**DRAINAGE LETTER
FOR
19580 FOUR WINDS WAY**

FEBRUARY 2022

CDR225

**19584 FOUR WINDS WAY
 MONUMENT, CO 80132
 EXISTING DRAINAGE PLAN**

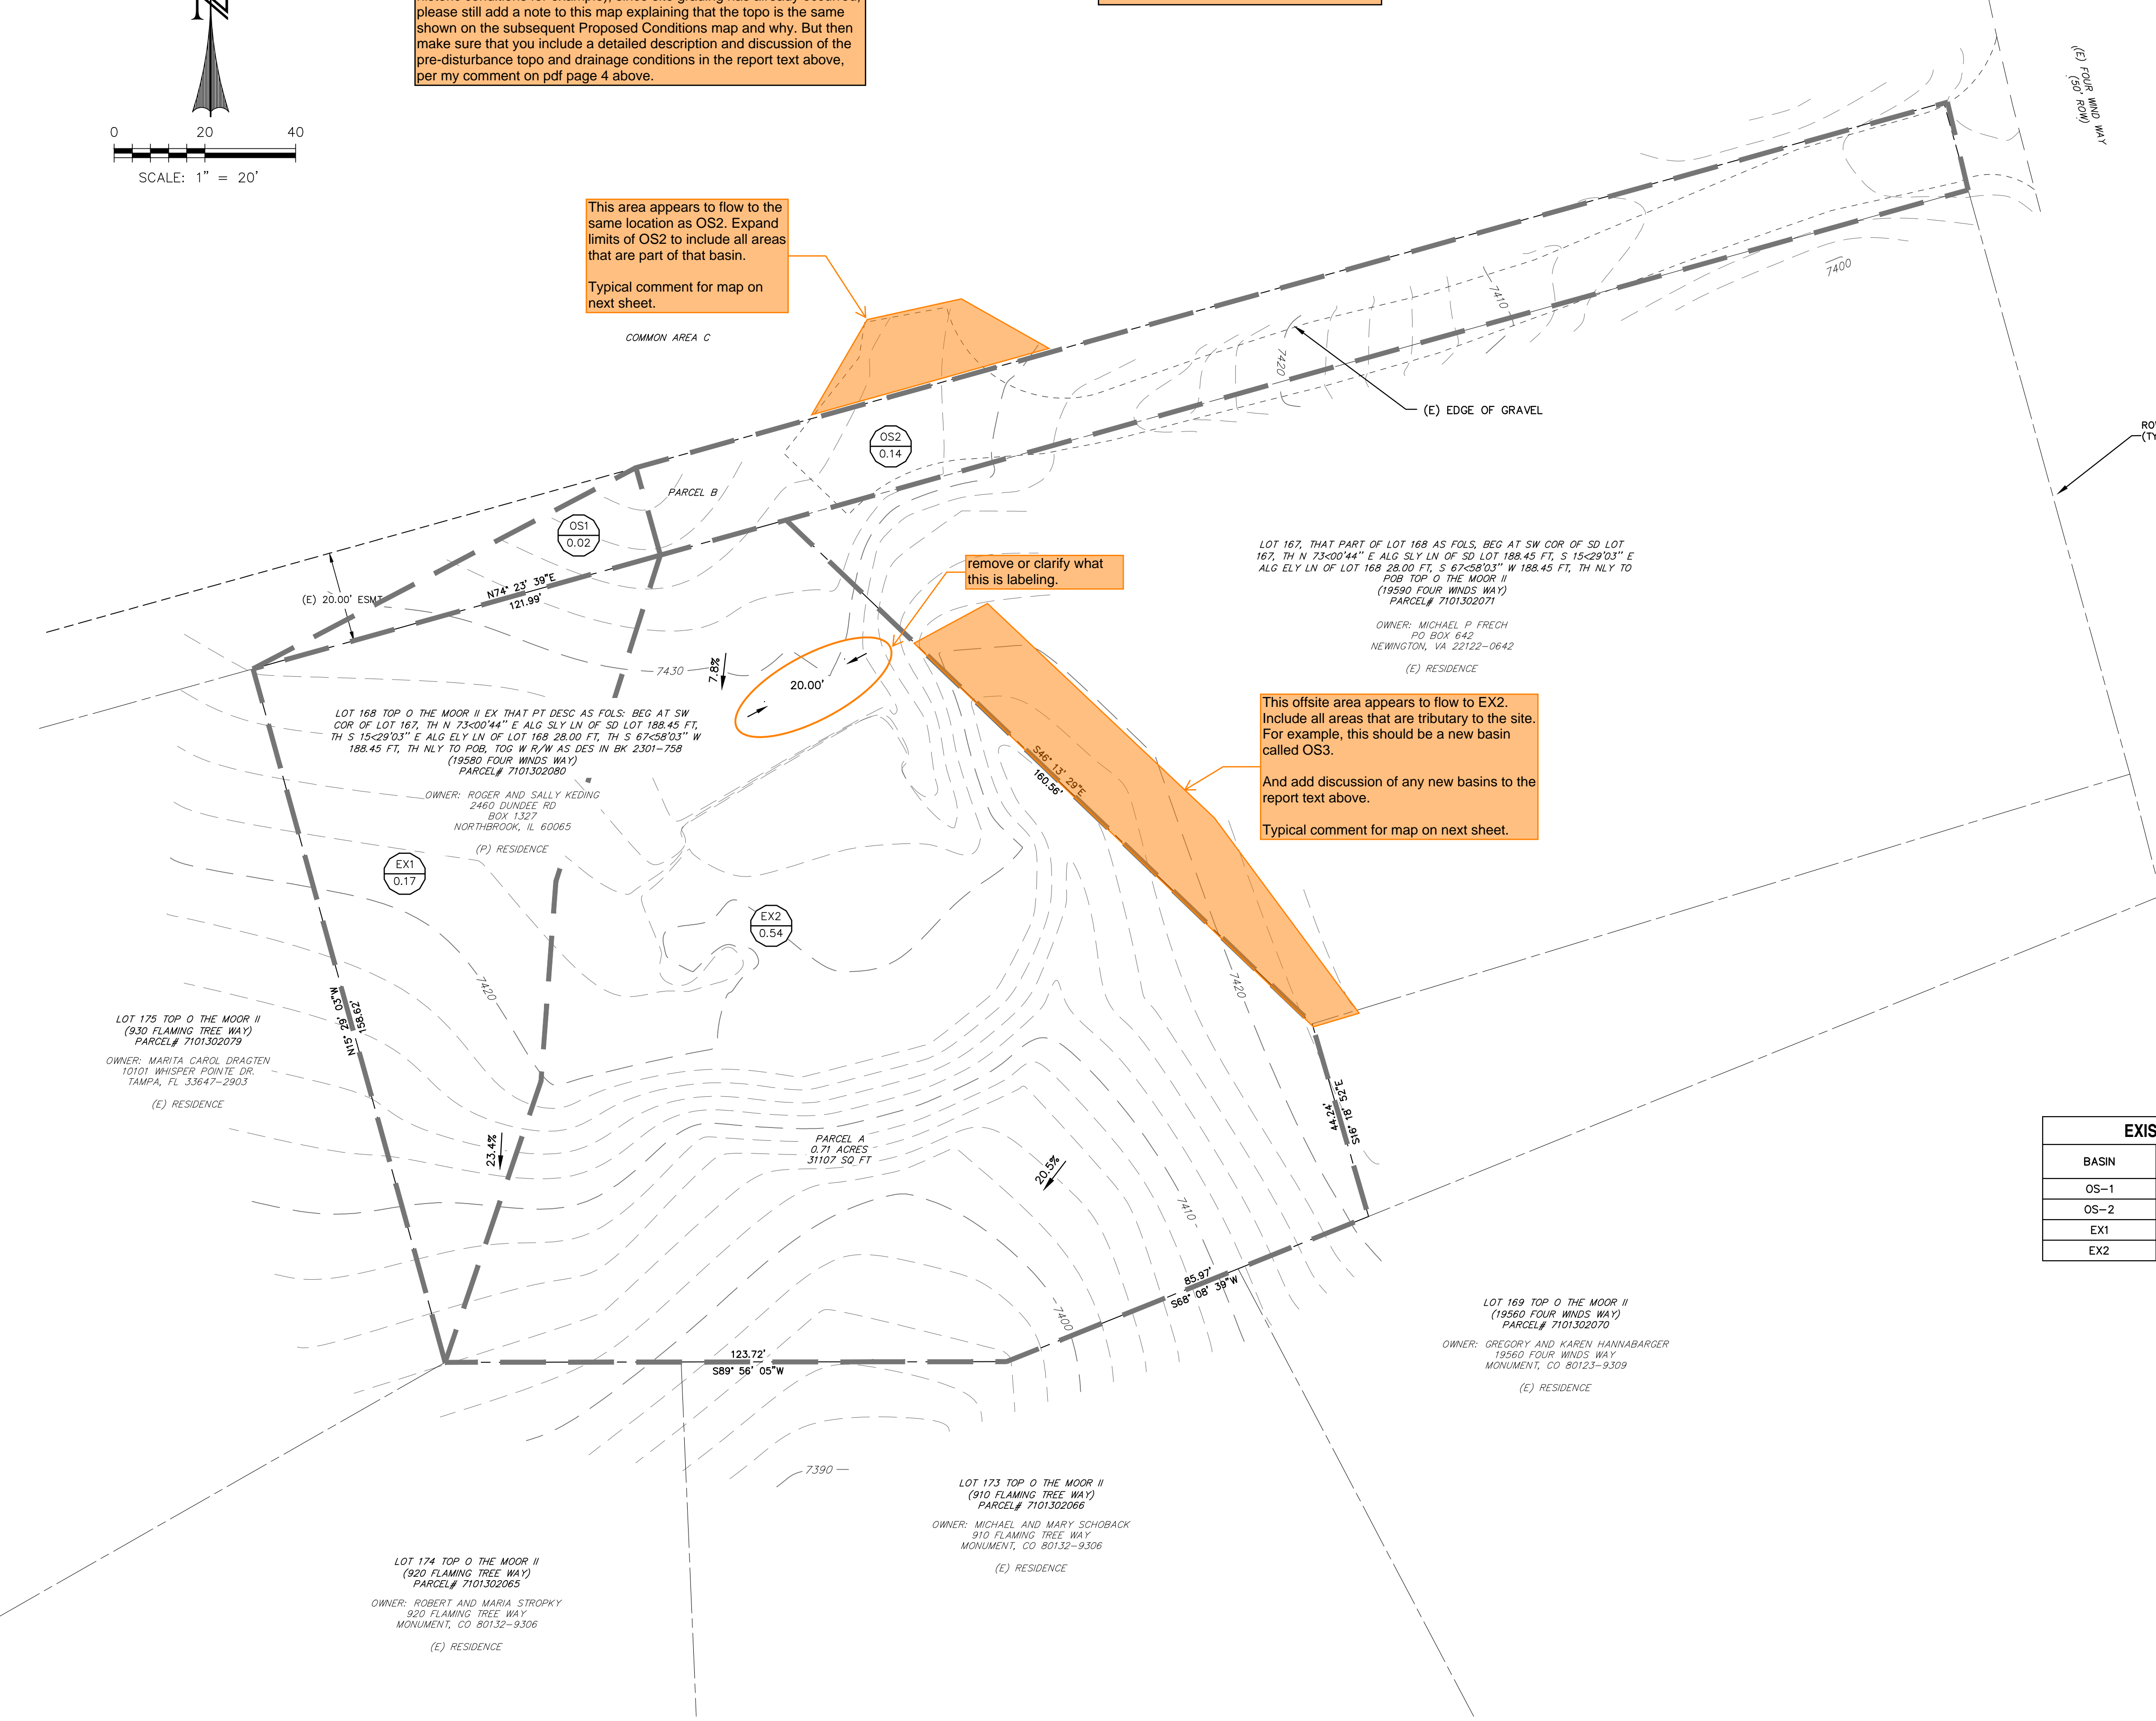
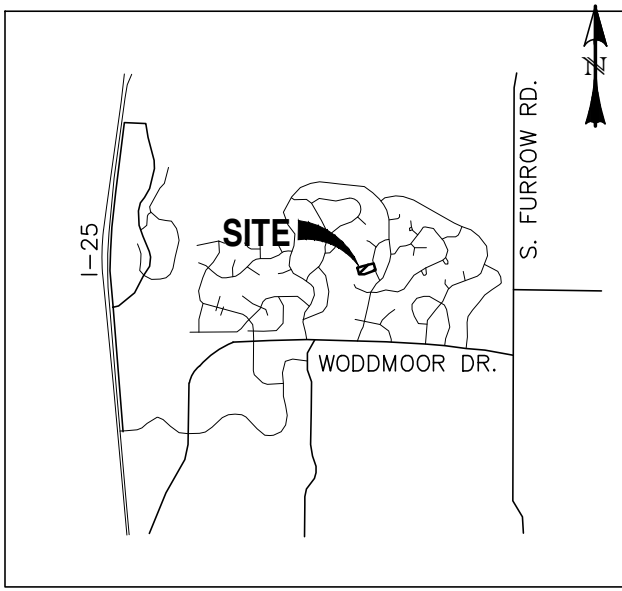
Notate date and source of topo survey.
 This should include the ditch/ravine area that was filled in with soil recently.
 If this topo does not exist (in publicly available sources that show historic conditions for example), since site grading has already occurred, please still add a note to this map explaining that the topo is the same shown on the subsequent Proposed Conditions map and why. But then make sure that you include a detailed description and discussion of the pre-disturbance topo and drainage conditions in the report text above, per my comment on pdf page 4 above.

Show flow direction arrows.

This area appears to flow to the same location as OS2. Expand limits of OS2 to include all areas that are part of that basin.
 Typical comment for map on next sheet.

remove or clarify what this is labeling.

This offsite area appears to flow to EX2. Include all areas that are tributary to the site. For example, this should be a new basin called OS3.
 And add discussion of any new basins to the report text above.
 Typical comment for map on next sheet.

19584 FOUR WINDS WAY
 MONUMENT, CO 80132
PROPOSED DRAINAGE PLAN

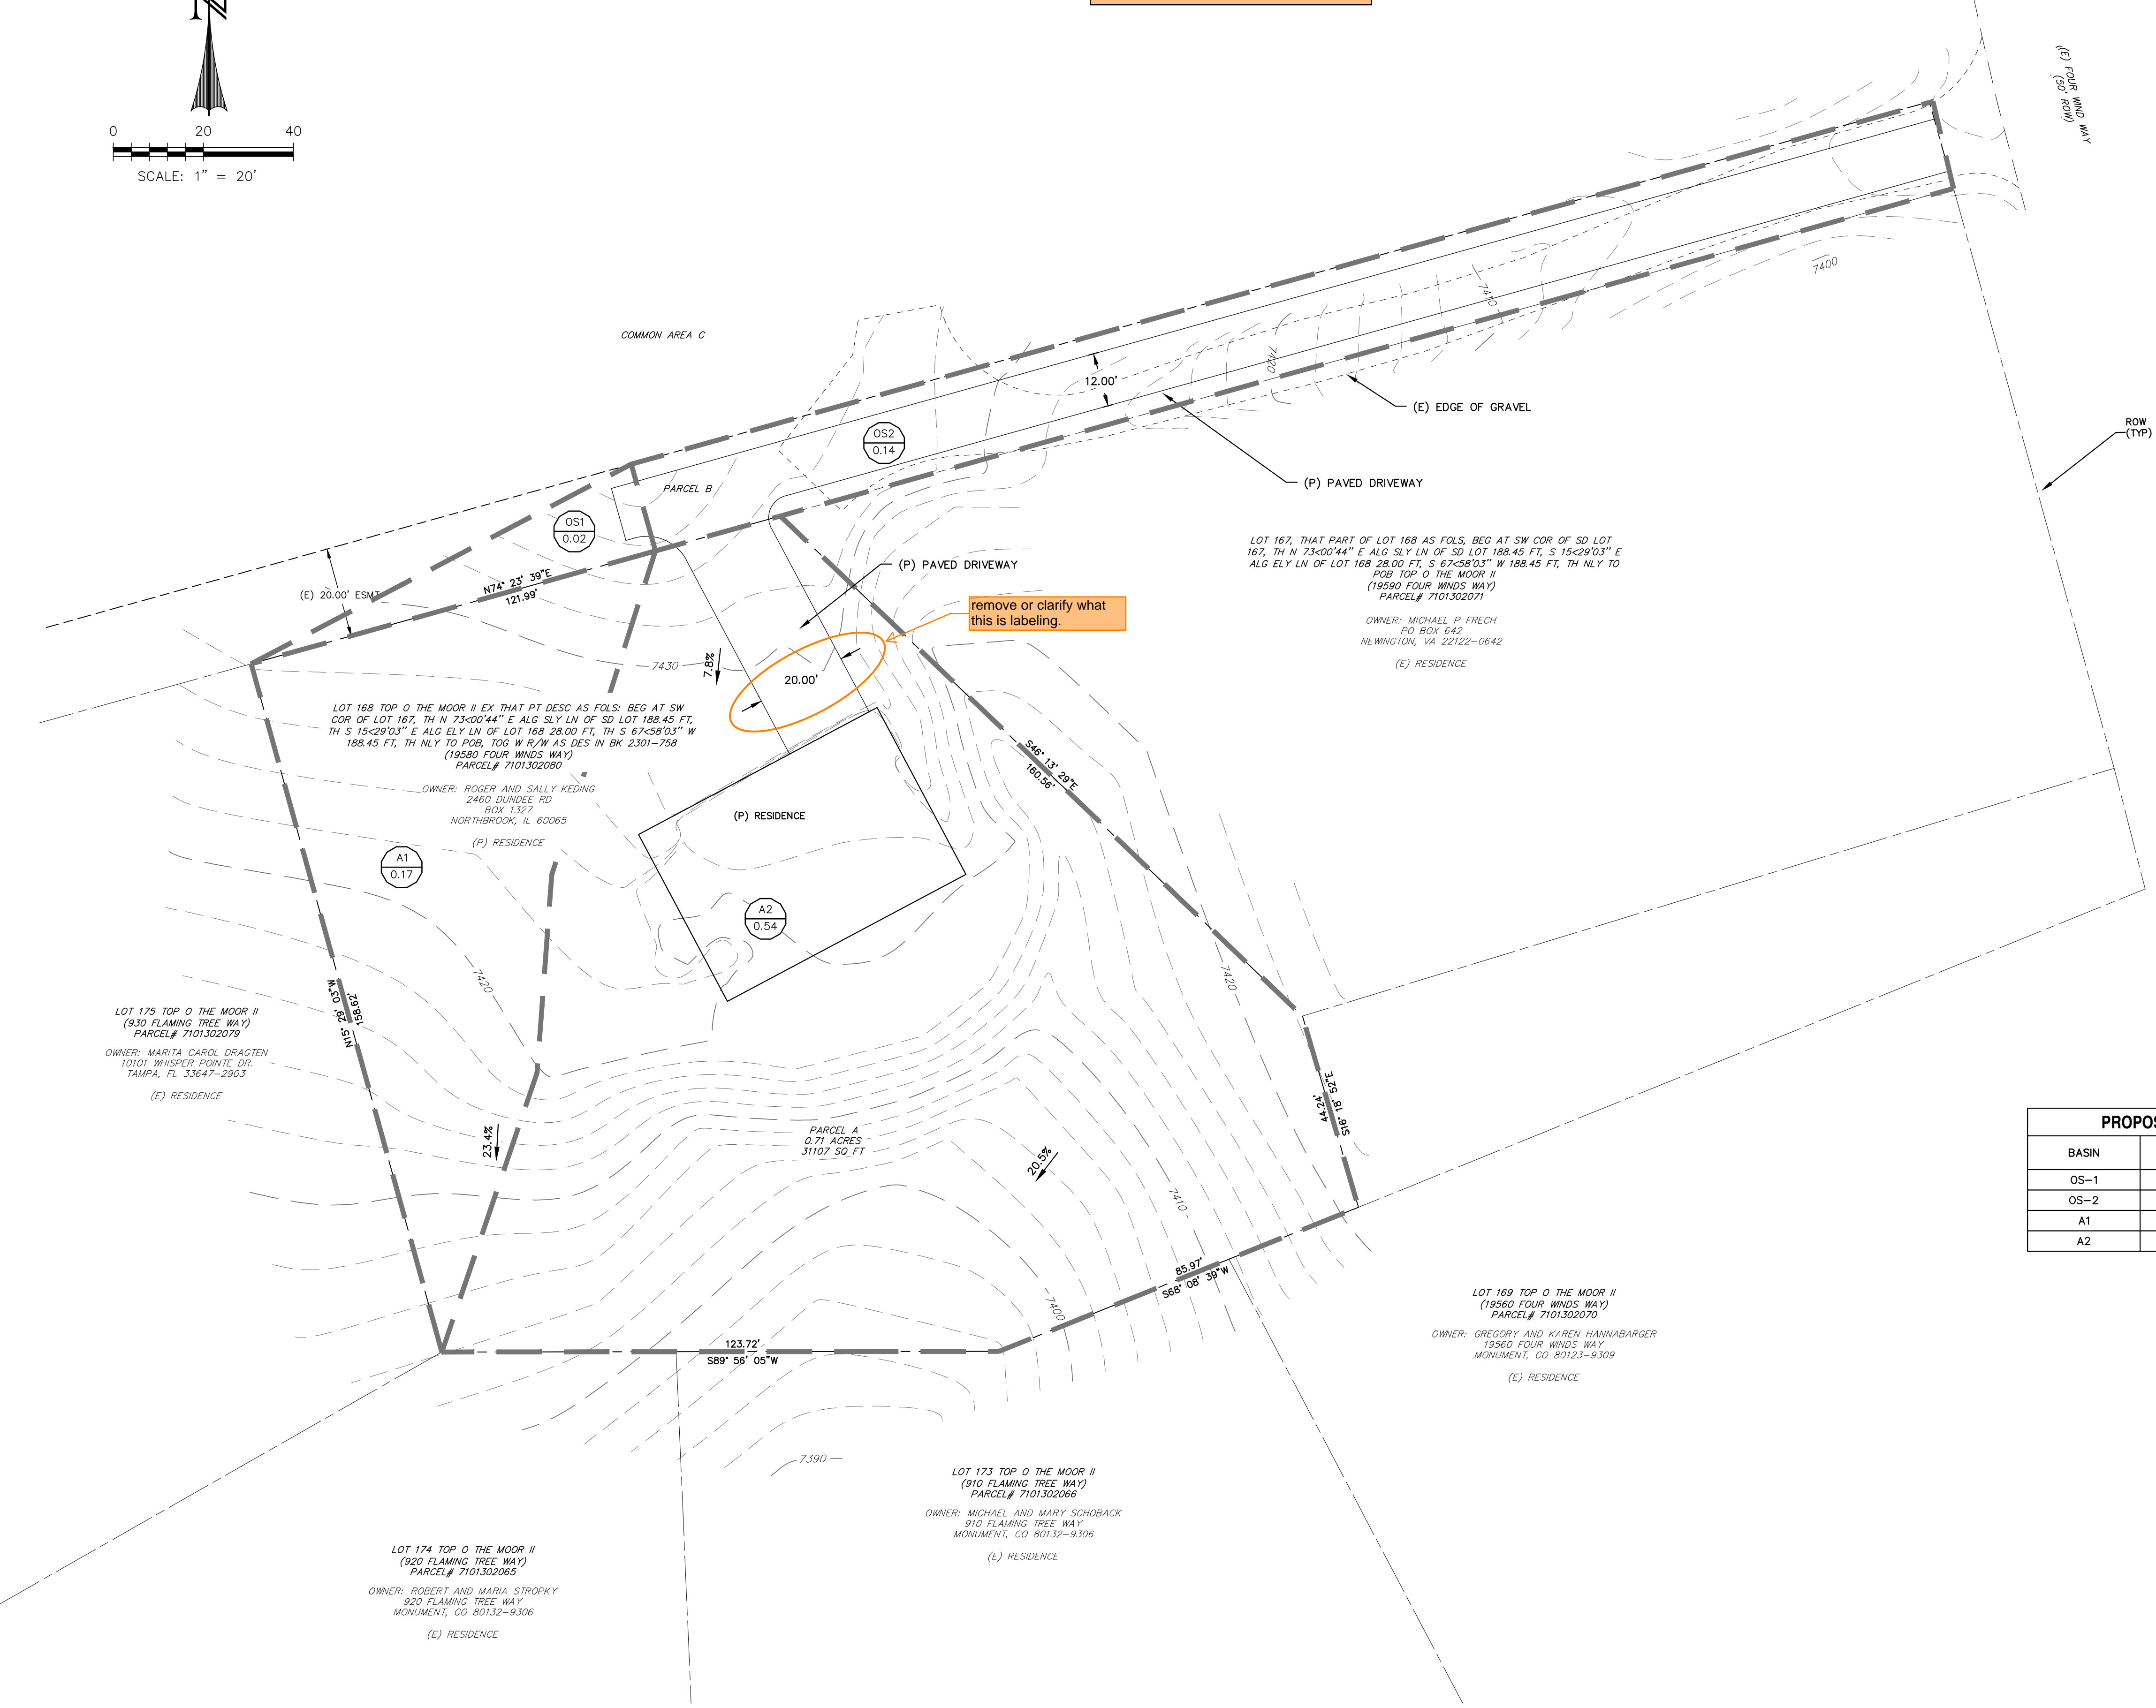
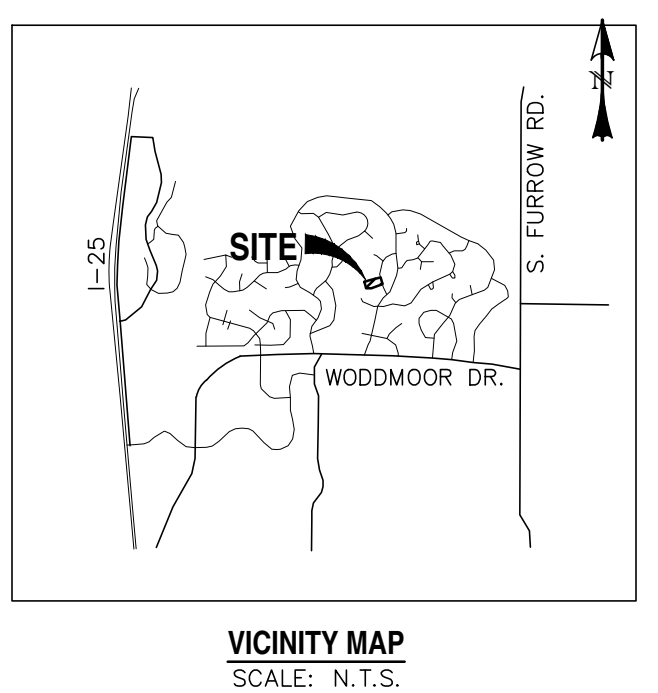
Notate date and source of topo survey.
 This map should show proposed topo, which should include a flat pad around the house.

Show flow direction arrows.
